ARLINGTON AVENUE BRIDGES REPLACEMENT

Design Review Committee Meeting #8 | December 13, 2022

Existing vs. 60% Design(North) CTWCD 14,000 cfs:

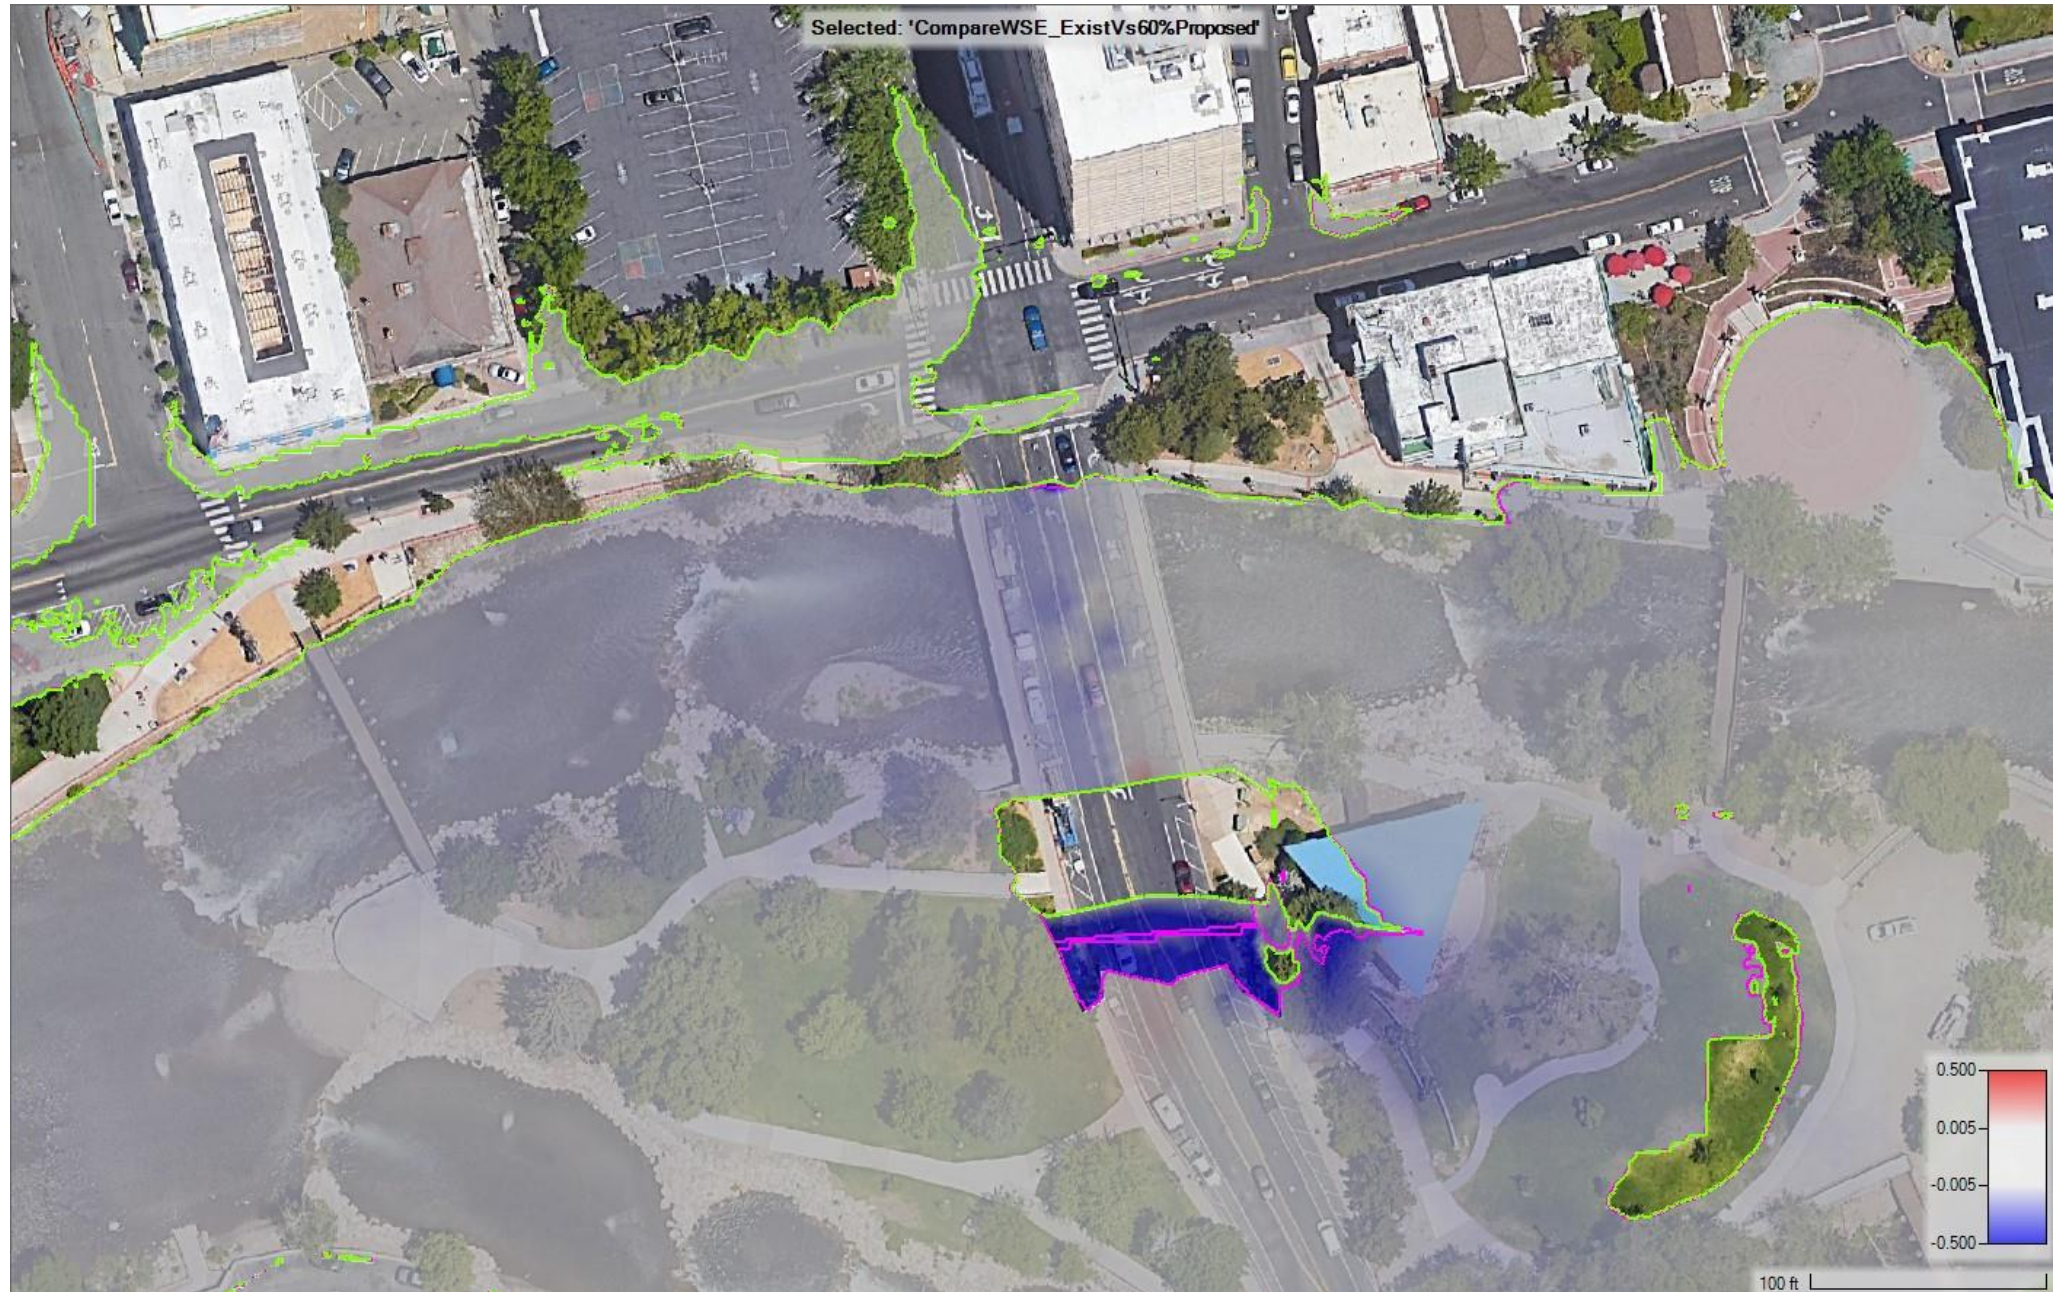
- Model Results – CTWCD 14,000 cfs
 - Existing Conditions
 - Confirmed to group that CTWCD district model is a 1D-2D mesh in the vicinity of Arlington Avenue.

- Existing WSE for 14,000 cfs is approximately 4497.5' to 4497.8' at the upstream side of the north bridge and approximately 4497.6' to 4497.8' at the upstream side of the south bridge

- Flows cross Arlington Avenue at the low point between the two bridges and at least a portion of the south bridge is inundated during a 14,000 cfs flow event.

- 60% Design vs. Existing Conditions
 - Flooding at W. First Street intersection is result of water getting out of bank farther upstream along Riverside Drive.

- Green delineation = existing conditions Pink delineation = 60% proposed design
 - WSE for proposed 60% design is 0 to 0.1' lower than existing conditions at the upstream side of the bridges. Kayla stated that the USACE concerns are public safety and want to ensure there is not water on the roadway.

- The **bridge deck of the north bridge is dry** with the 60% proposed design
 - The bridge deck of the **south bridge will not be dry** because, as occurs during existing conditions, the profile of Arlington Avenue has a low point through Wingfield Park just north of the south bridge and **water will encroach onto the south bridge deck as it flows through the park and across Arlington Avenue** at this location.

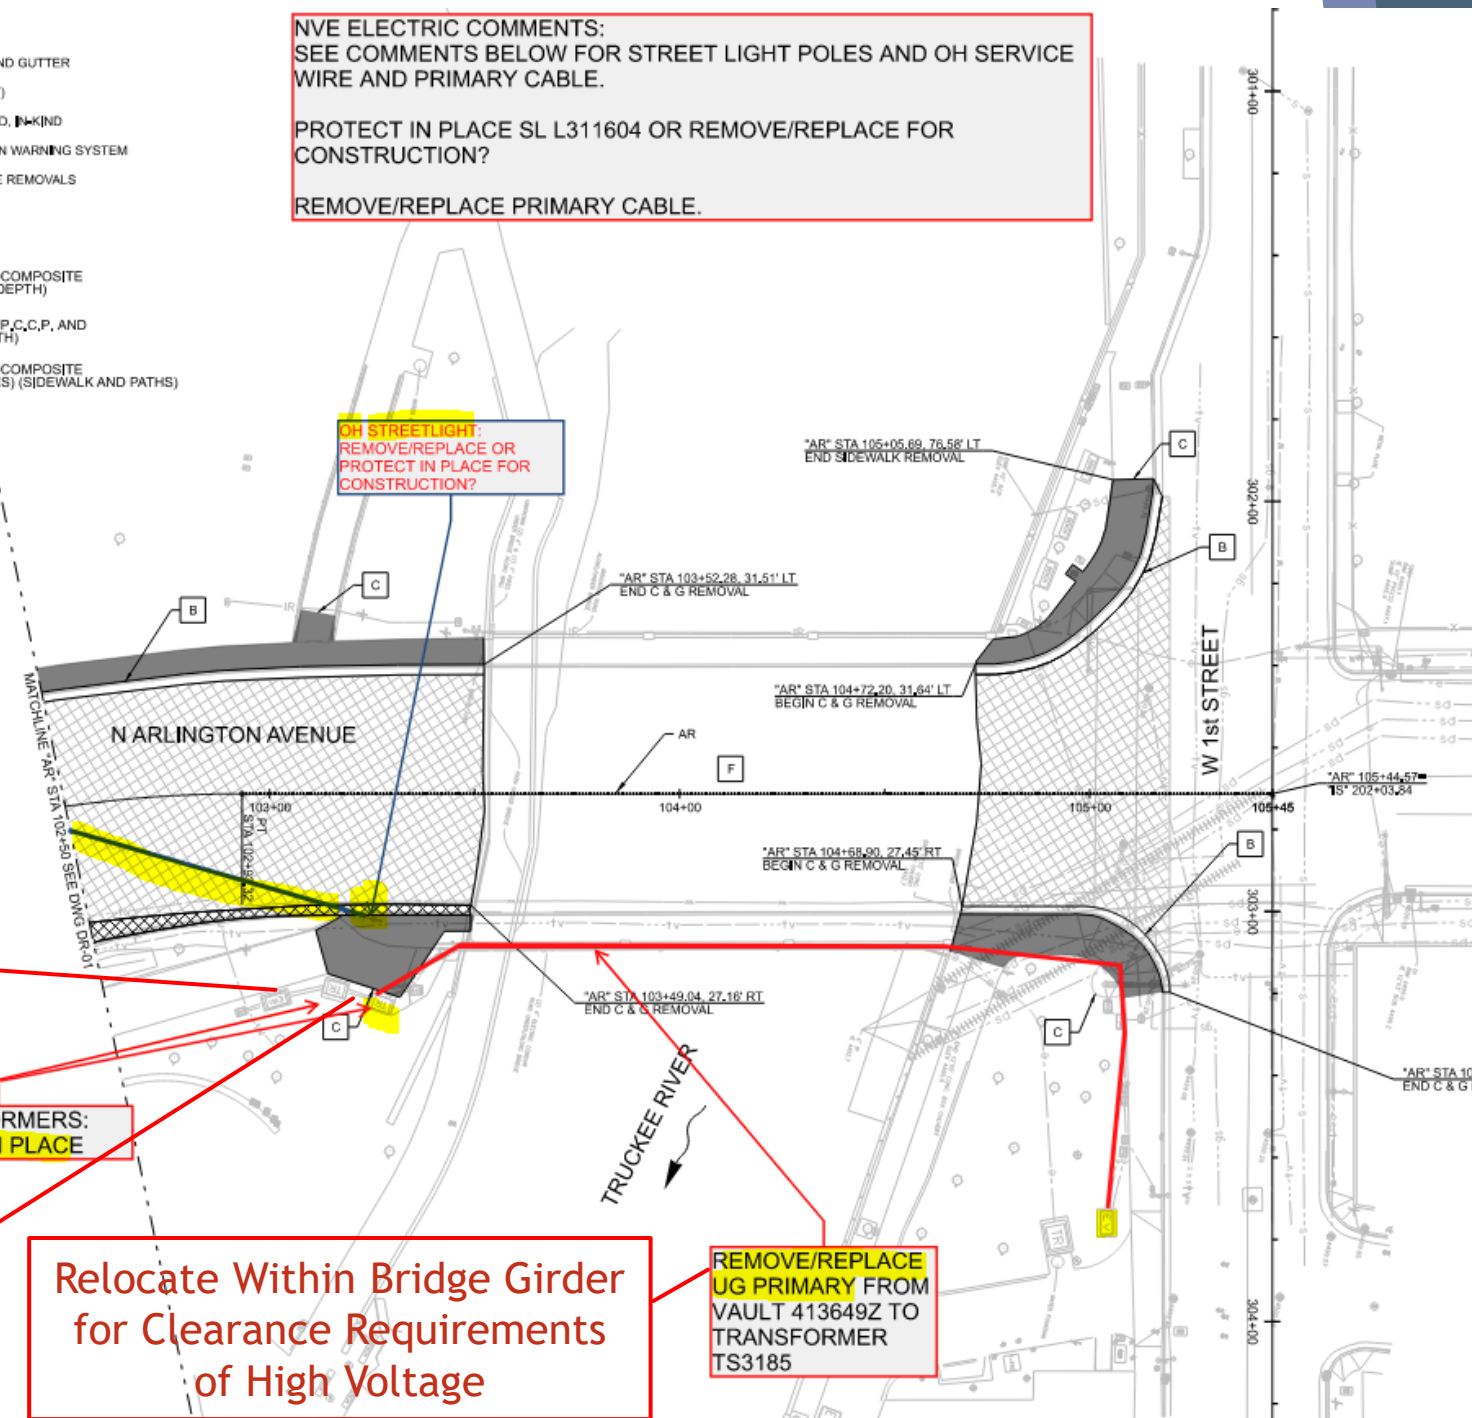
NVE ELECTRIC COMMENTS:
SEE COMMENTS BELOW FOR STREET LIGHT POLES AND OH SERVICE WIRE AND PRIMARY CABLE.

PROTECT IN PLACE SL L311604 OR REMOVE/REPLACE FOR CONSTRUCTION?

REMOVE/REPLACE PRIMARY CABLE.

2-TRANSFORMERS:
PROTECT IN PLACE

NVE Transformers (2)
Middle One is Empty - Can be removed or repurposed

Relocate Within Bridge Girder for Clearance Requirements of High Voltage

REMOVE/REPLACE UG PRIMARY FROM VAULT 413649Z TO TRANSFORMER TS3185

NVE - ELECTRIC

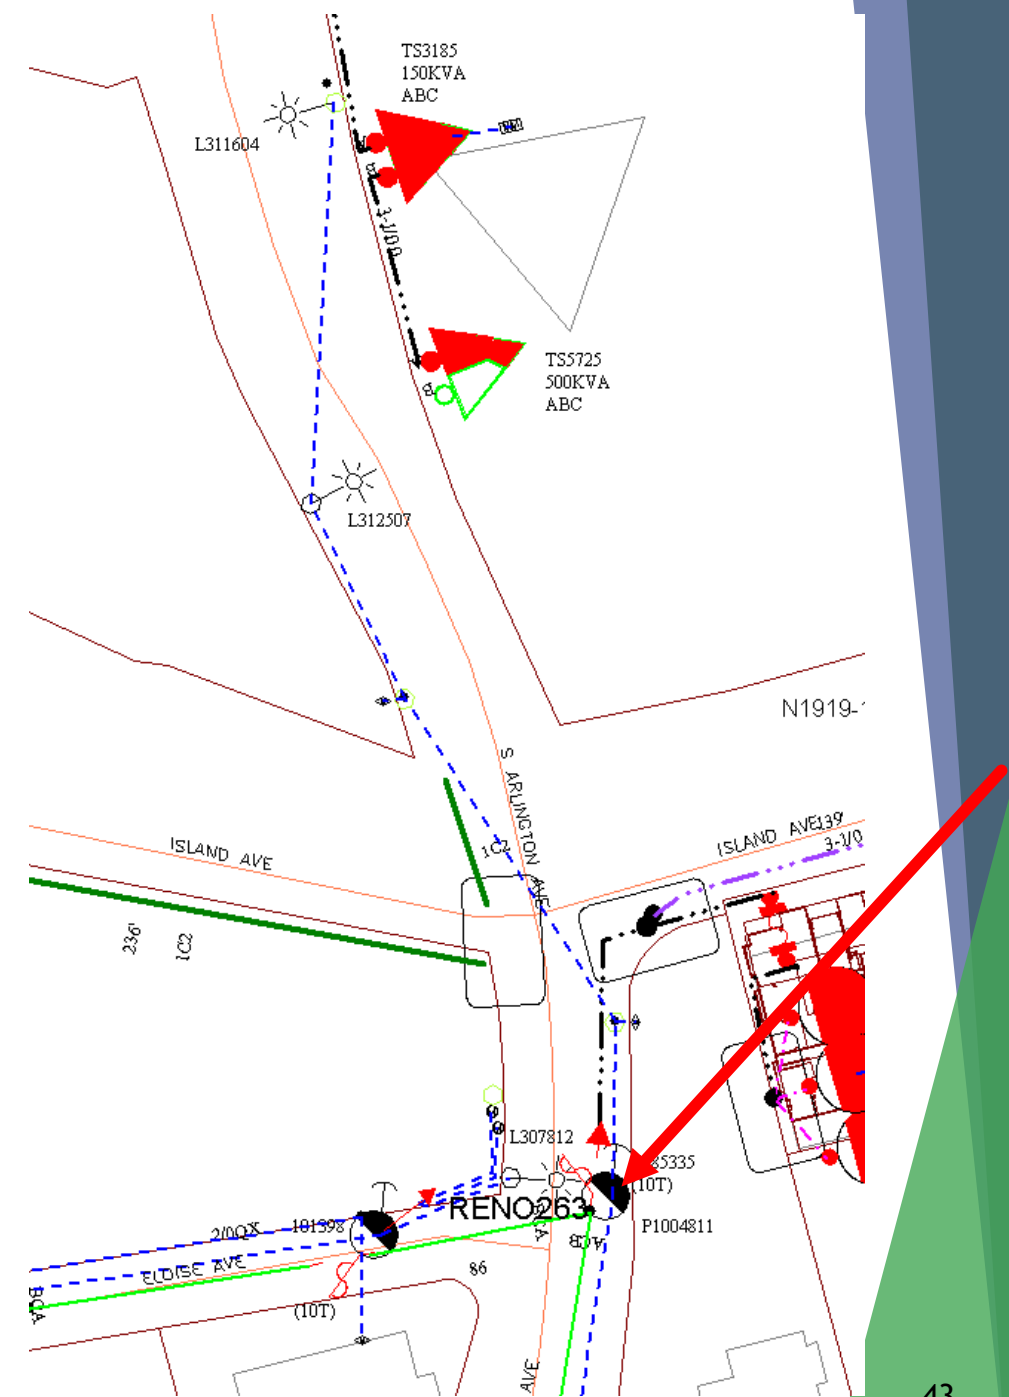
- Underground the existing Overhead
- Pole - P1004811 at end of Elsie Ave.

ZAYO (Gary Getchell, Robert Alford)

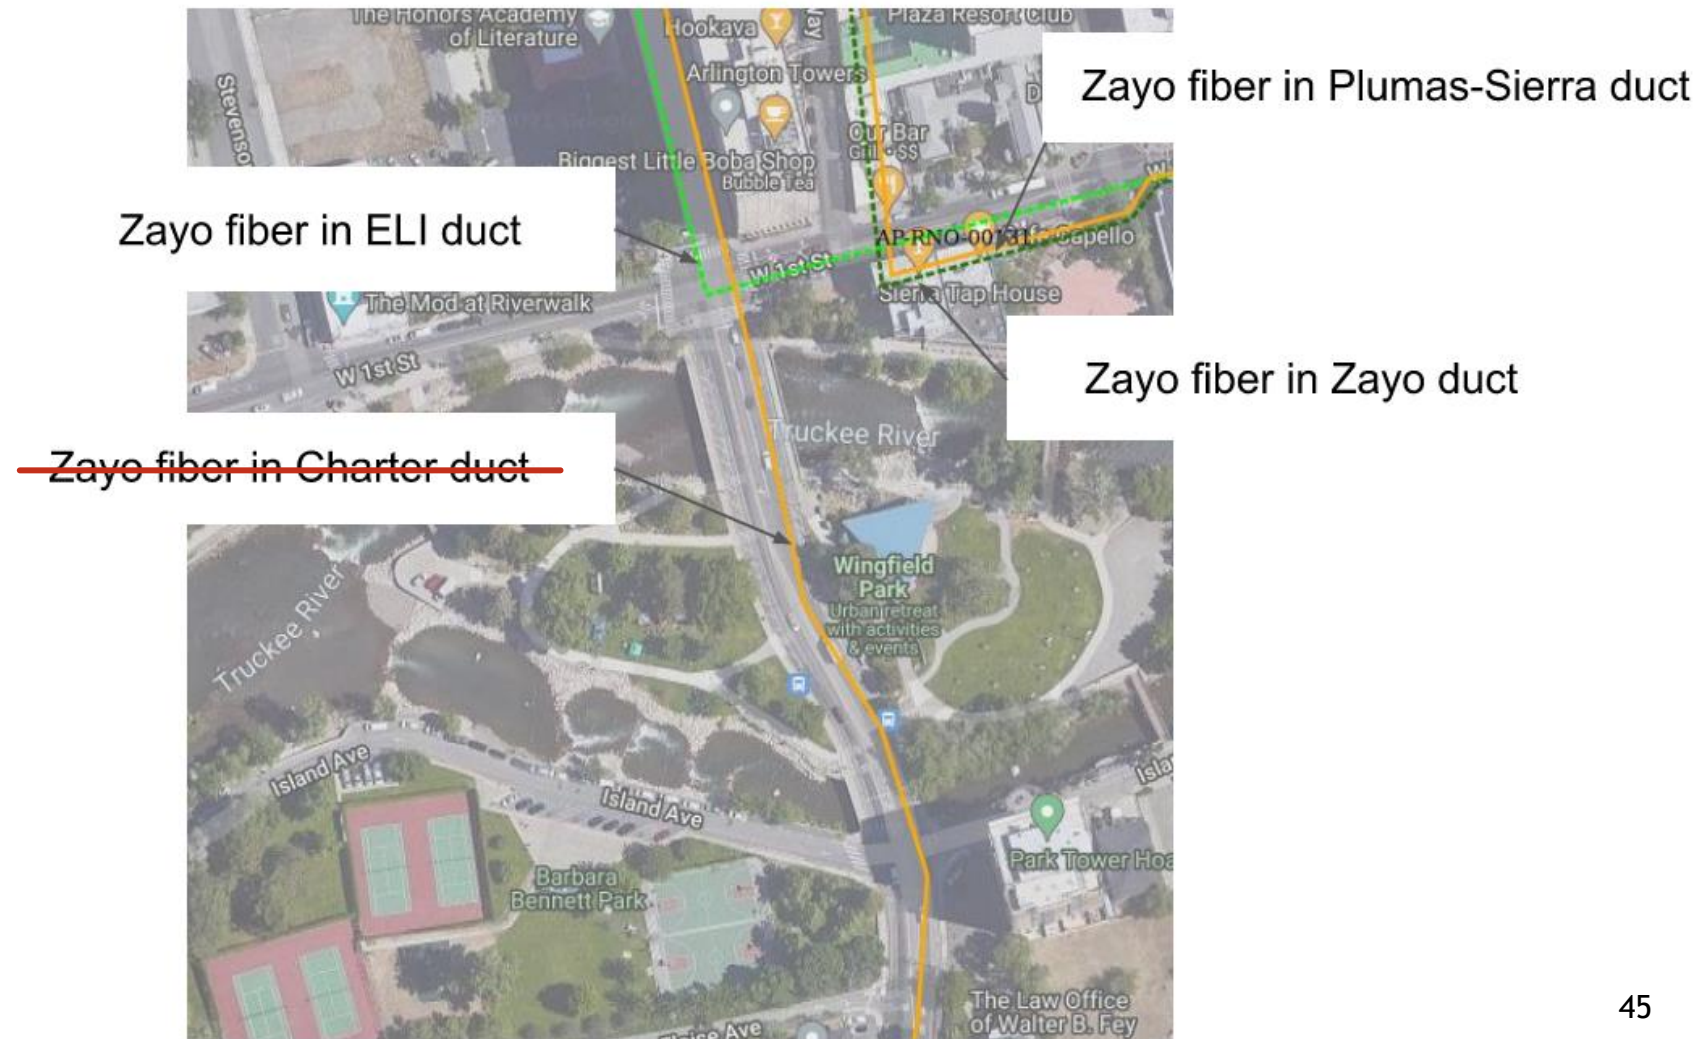
- * No Zayo Fiber in Charter Duct across South Bridge to Amphitheater
- * Zayo would like to have conduit across both bridges and along Arlington between bridges; 2-2" min

AT&T (Steve Lewis, Clifford Cooper)

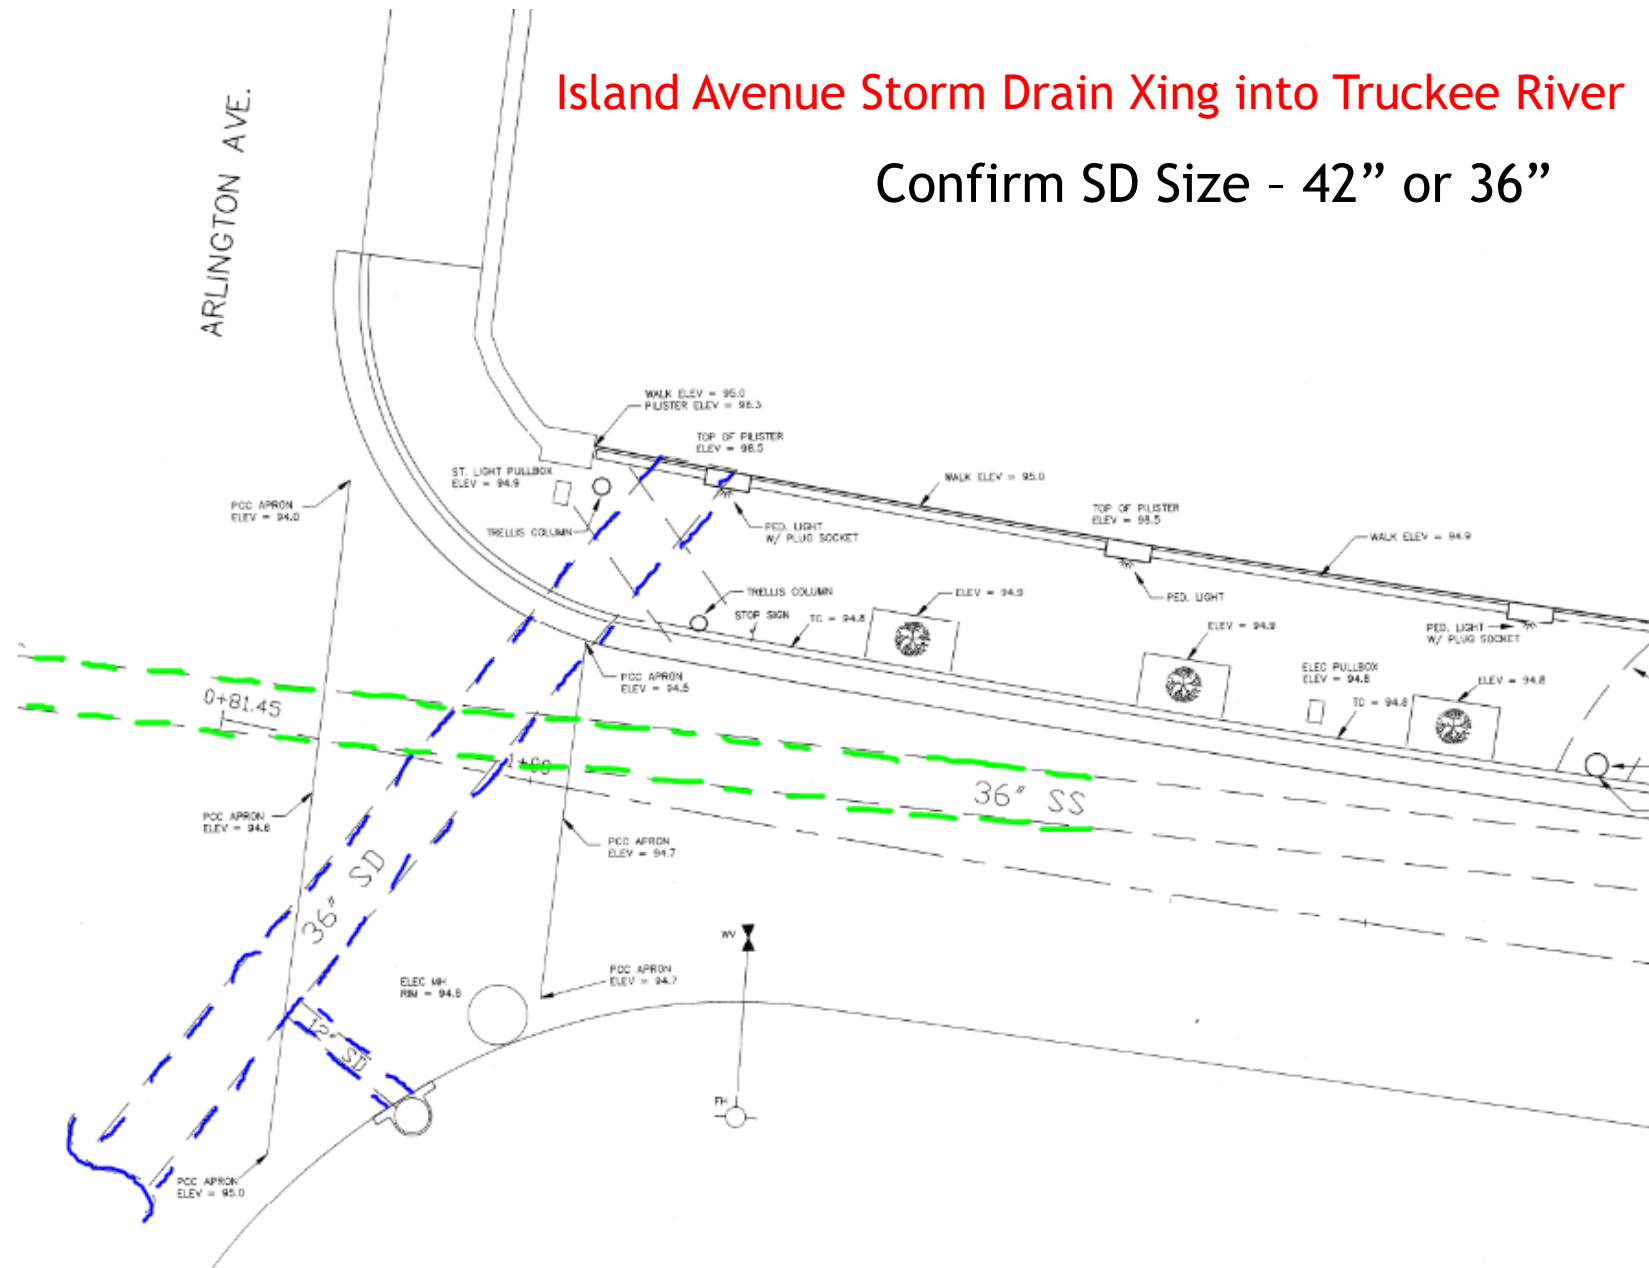
7-4" Conduits requested across both bridges and along Arlington

Confirm SD Size - 42" or 36"
